REQUEST FOR INFORMATION	DATE: March 29, 2017	NO.: RFI-501
--------------------------------	-----------------------------	---------------------

Project Name: 15051-Webster University Interdisciplinary Science Building

Subject: Vacuum Pump Exhaust Vent and Natural Gas Venting Locations

Drawing Title:
**LEVEL 01 AREA A FLOOR
PLAN**

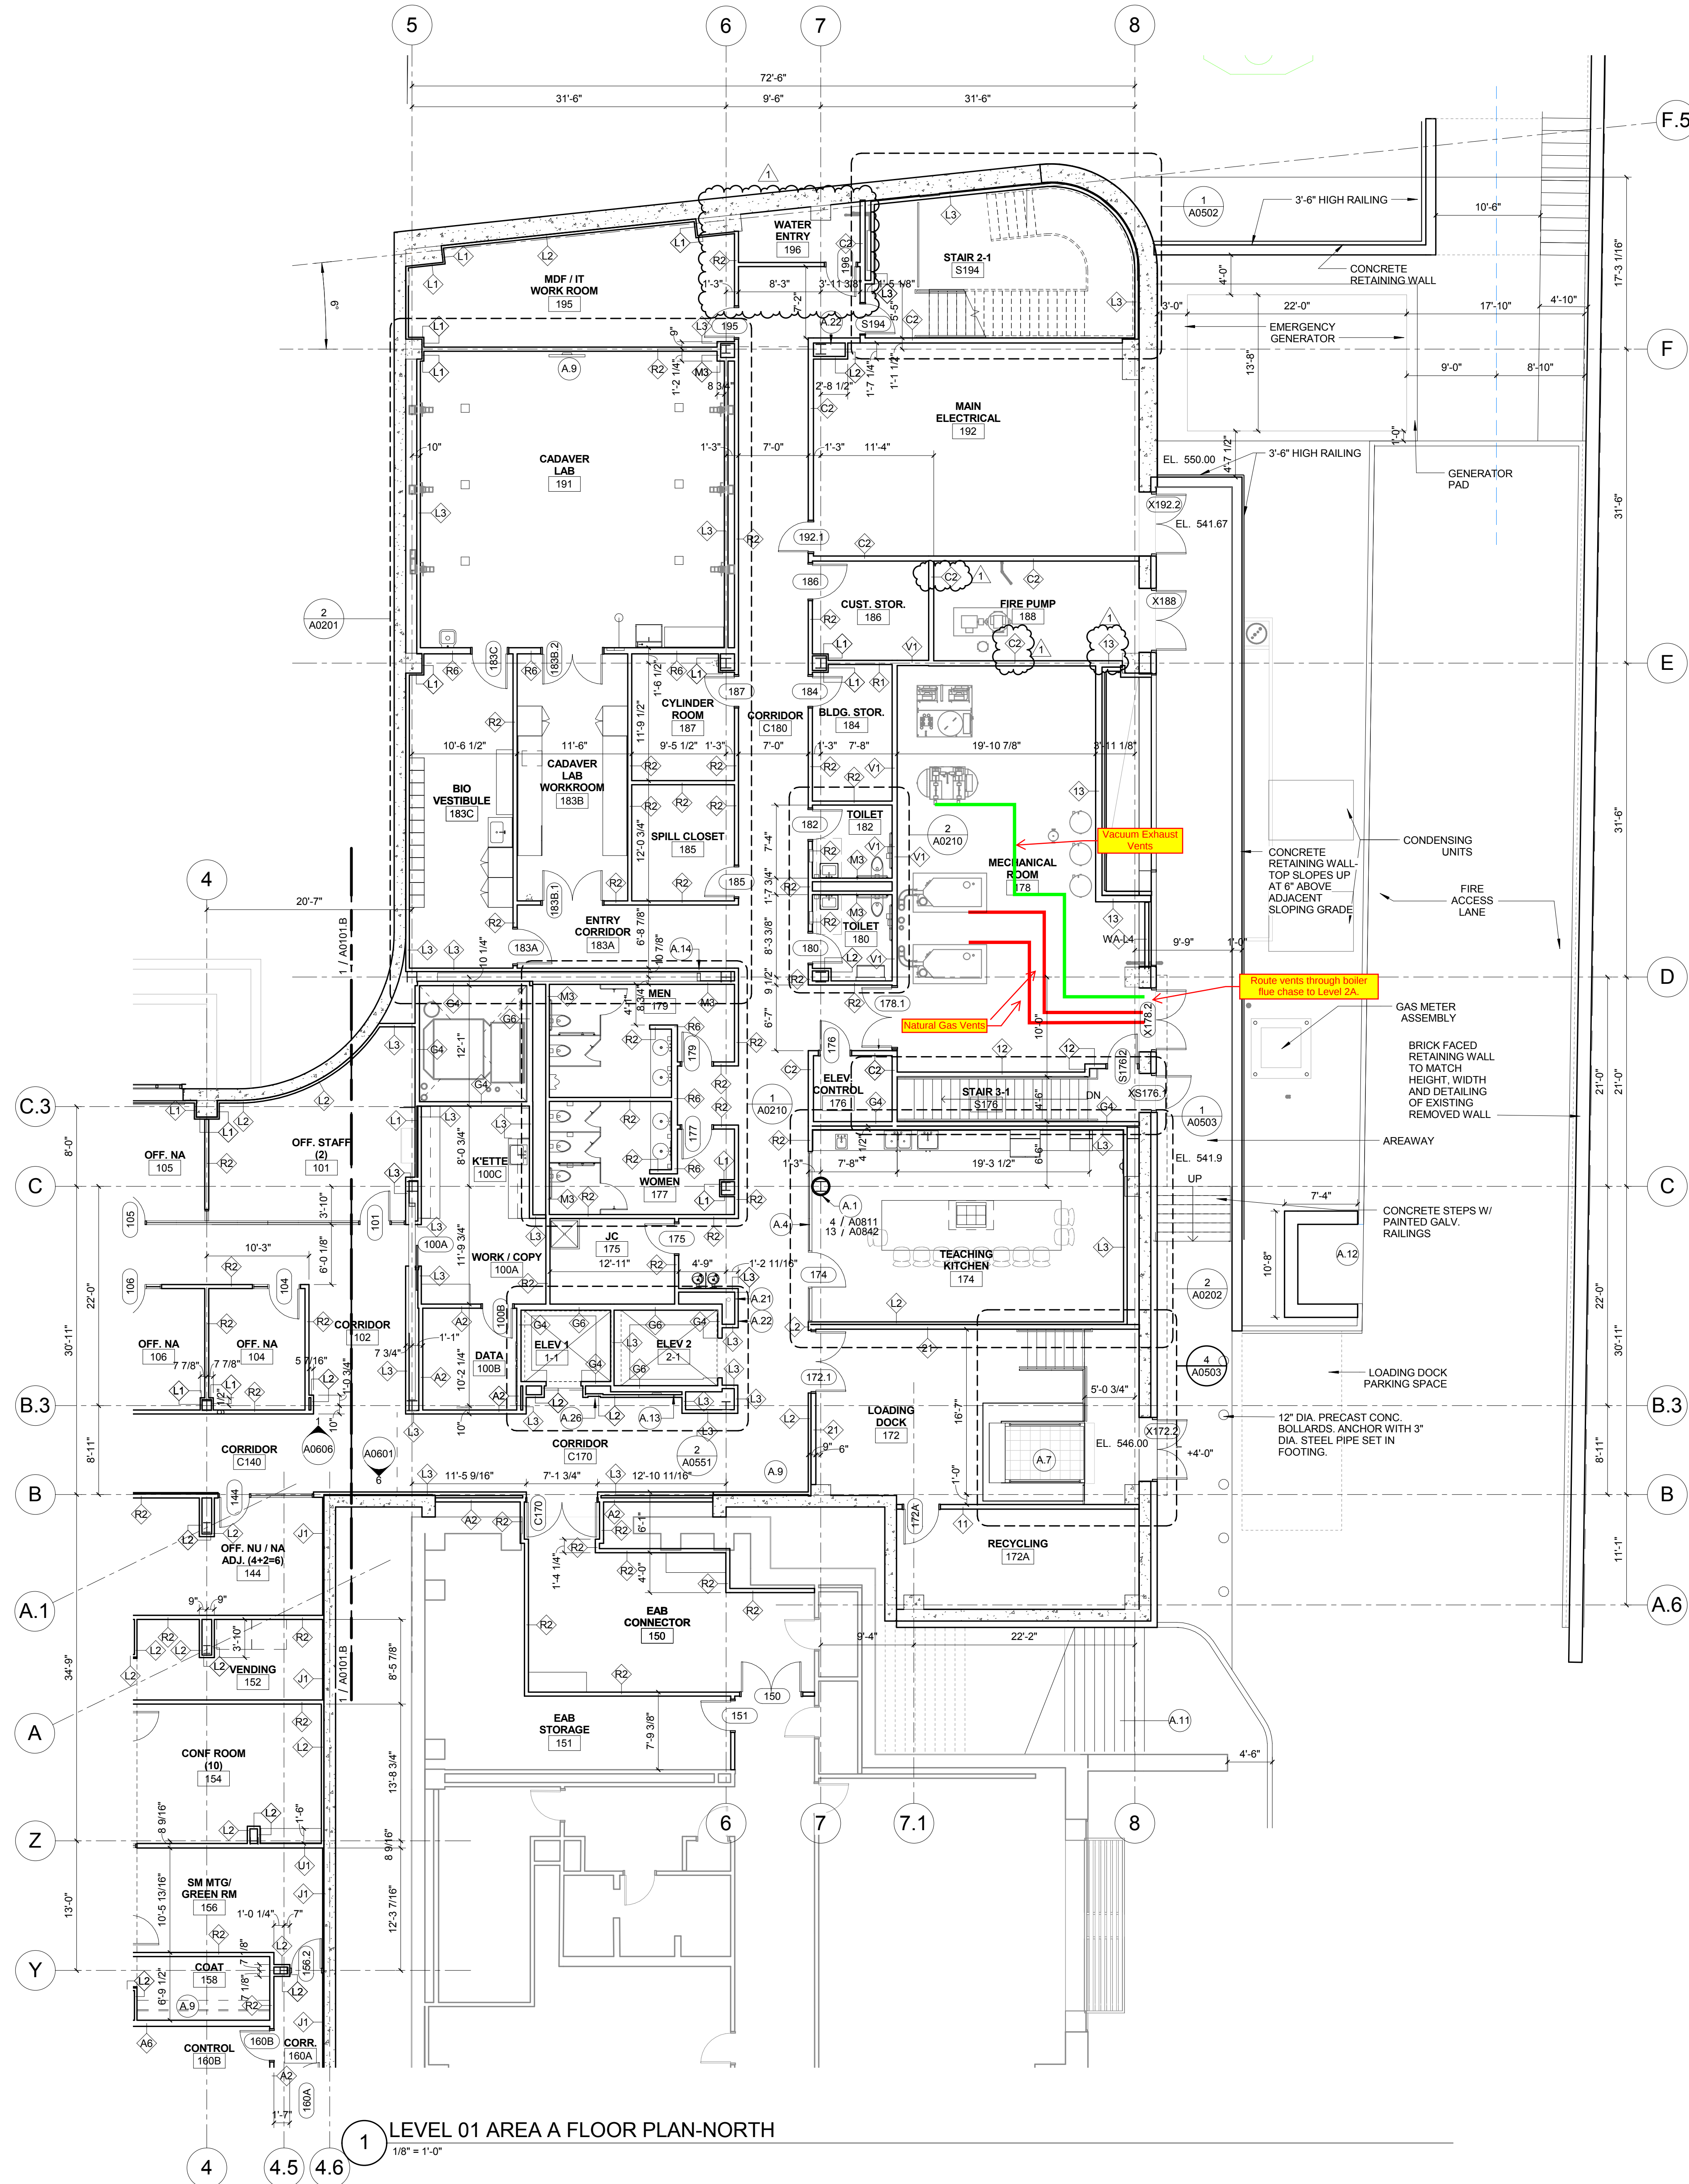
Proposed natural gas and vacuum pump exhaust vent locations are attached. Locations chosen to follow applicable code (below) and to be concealed as much as possible. Vents will be between 6' and 10' above intake louver. All three vents will turn down to prevent water/debris infiltration.

2009 IMC states in section 401.4 "intake opening shall be located not less than 3ft below contaminant sources where such sources are located within 10ft of the opening."

Contractor proposed vent pipe discharge locations appear to be acceptable to WTA and meet the intent of the Code. Contractor to properly install any dissimilar metals to avoid galvanic corrosion. Architect has requested vent pipes to be painted to match the exterior of the building. Coordinate color and final location with Architect.
